Advanced Technical Information

Bulletin #: 2014.1

AC Charging Hardware and Cable Temperature

Figure 1

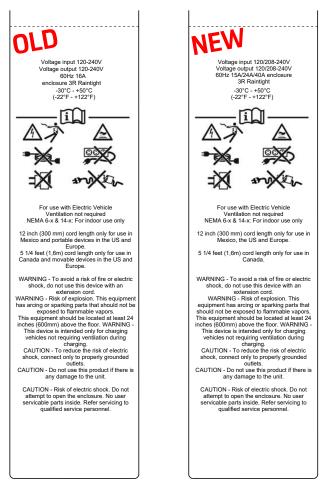
Errors exist in the label affixed to supply cables provided with vehicles produced before August, 2020, as well as cables currently available via normal parts channels.

Only one label variant exists and is affixed to all supply cables in USA and Canada (NEMA5-15, 6-/14-30, and 6-/14-50). Figure 1 shows the existing label with errors. Figure 2 shows the updated label.

The necessary recourse for labels with errors is being evaluated.
